ADDENDUM NO. 3

PROJECT NAME: Life Sciences Annex – North and East Wing Renovations
UNL PROJECT NUMBER: A090P025 & A090P026

DATE OF ISSUANCE: February 10, 2012
DATE OF BID OPENING: Tuesday February 14, 2012 @ 2:00 p.m. CDT-Changed below!

First Floor Plumbing Demolition Plan Area "C"

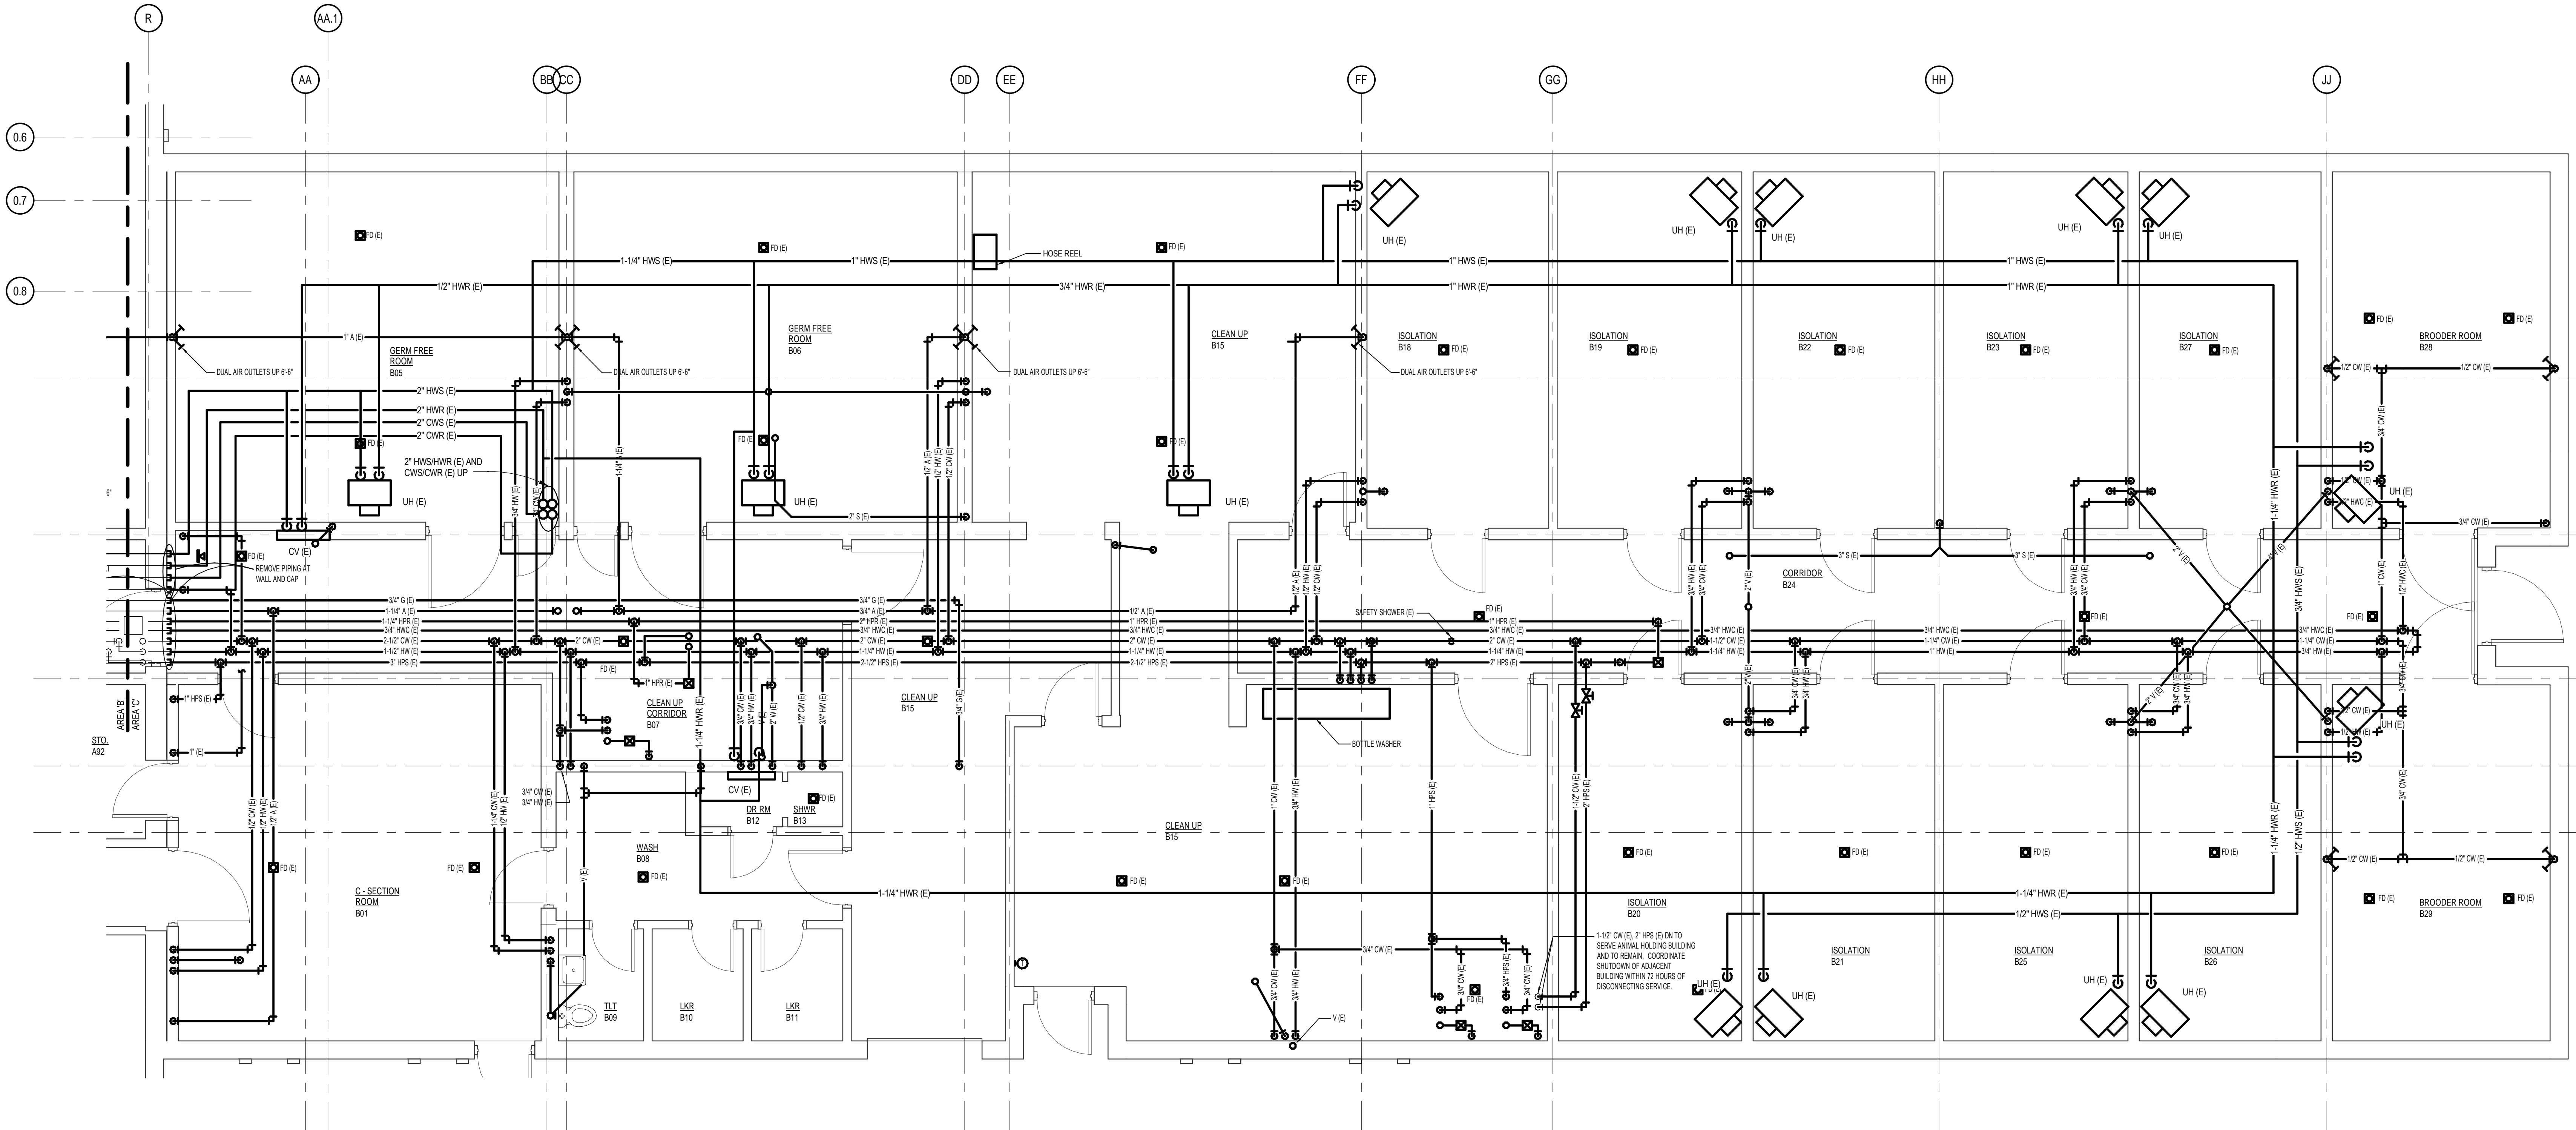
ITEM #3 Refer to Sheet P0.06 – First Floor Plumbing Demolition Plan Area ‘C’

- a. See attached for revised demolition plan: CWS CWR, HWS, and HWR piping and associated mechanical equipment (unit heaters, etc.) demolition has been added to sheet.
